From: [Yu, Olivia, EMNRD](#)
To: ["Katie Jones"](#)
Subject: RE: EME E-21 AD (1RP-5127) Proposed Path Forward
Date: Tuesday, August 28, 2018 1:45:00 PM

From: Katie Jones <kjones@riceswd.com>
Sent: Tuesday, August 28, 2018 10:50 AM
To: Yu, Olivia, EMNRD <Olivia.Yu@state.nm.us>
Subject: EME E-21 AD (1RP-5127) Proposed Path Forward

EME
E-21 AD

UL E SECTION 21
T-22-S R-36-E
LEA COUNTY, NM

Initial Sampling

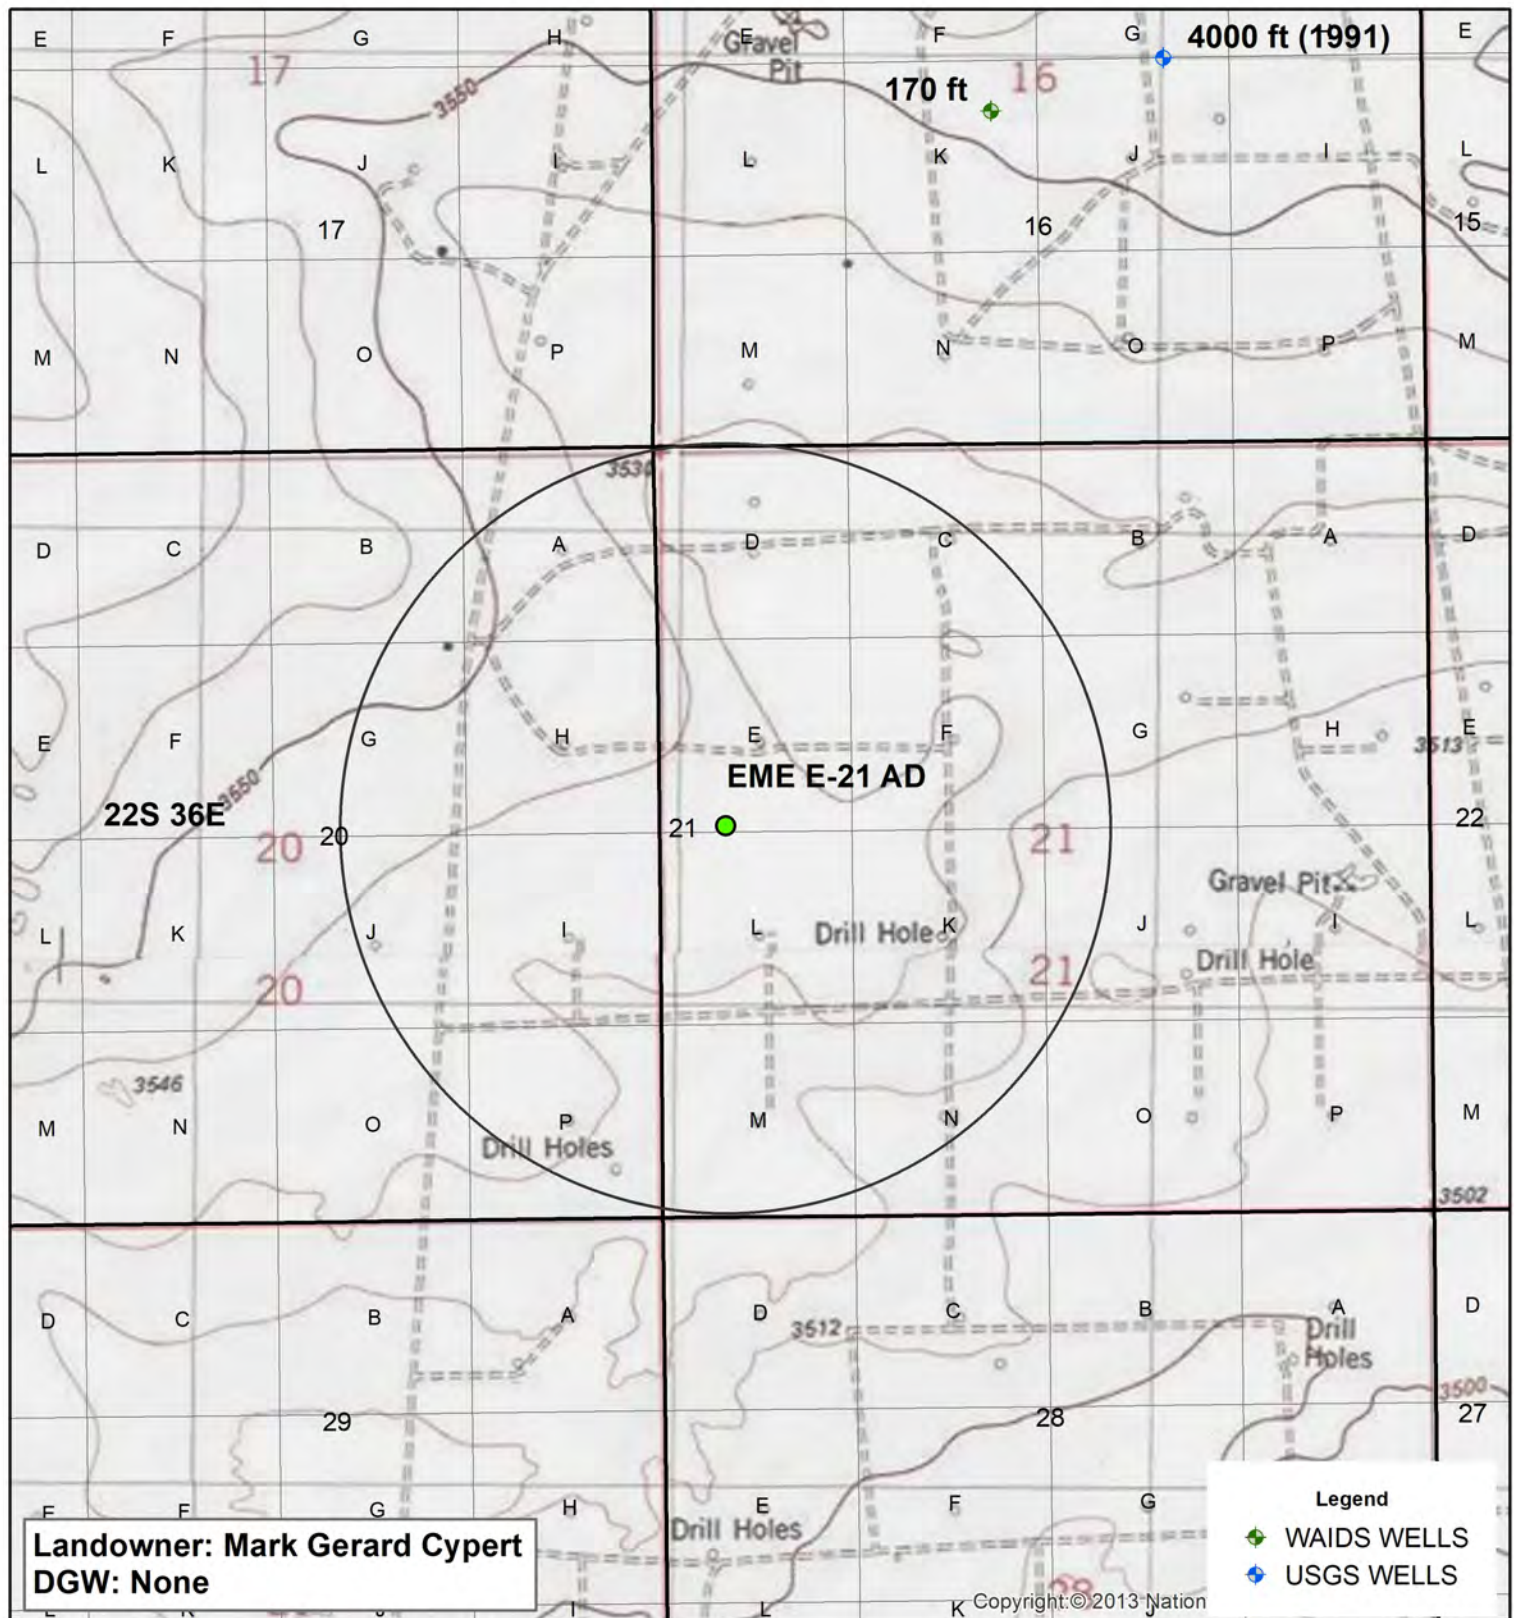
Thank you for these meeting minutes of our phone conversation this morning. As previously mentioned, NMOCD strongly recommends a soil bore to be located in the release area to complete vertical delineation of 1RP-5127, in case there is a water bearing zone within 100 ft. bgs.

Please be advised that the release will need to have Benzene, BTEX, and TPH extended characterized as well.

In order to apply Table 1 values, the guideline is to use a 0.5 mile radius to assess depth to groundwater, similar to the radius for wellhead protection and distance to nearest significant watercourse. For 1RP-5127, neither USGS nor NMOSE wells are within 0.5 mile radius. If another source(s) of data is used for determination, please provide according to 19.15.29.11A(2).

Also, please keep in mind 19.15.29.13A. For releases impacting pasture, site and release characterization/delineation data must be sufficient to determine the vertical and horizontal extents, to which remediation will occur for subsequent successful restoration and revegetation.

- Drill a background soil bore, which will be located approximately 100 ft southeast of the accidental discharge source. The bore will be drilled to a depth of 115 ft bgs, with soil samples collected at regular intervals to determine lithology only. The purpose of this bore is to determine that depth to groundwater is greater than 100 ft bgs. The bore will remain open for approximately 48 hours and gauged to check for moisture accumulation.

- If groundwater is determined to be greater than 100 ft bgs, ROC will submit a corrective action for the site which will likely include installing a 20-mil, reinforced liner over the accidental discharge area at a depth of 4-5 ft bgs. Then backfilling and contouring the site to the surrounding area, and seeding.

- If groundwater is found at a depth shallower than 100 ft bgs, ROC will delineate the site to the requirements listed in Table 1 listed in 19.15.29.12 NMAC. This will possibly require a second soil bore to be drilled closer to the accidental discharge source.
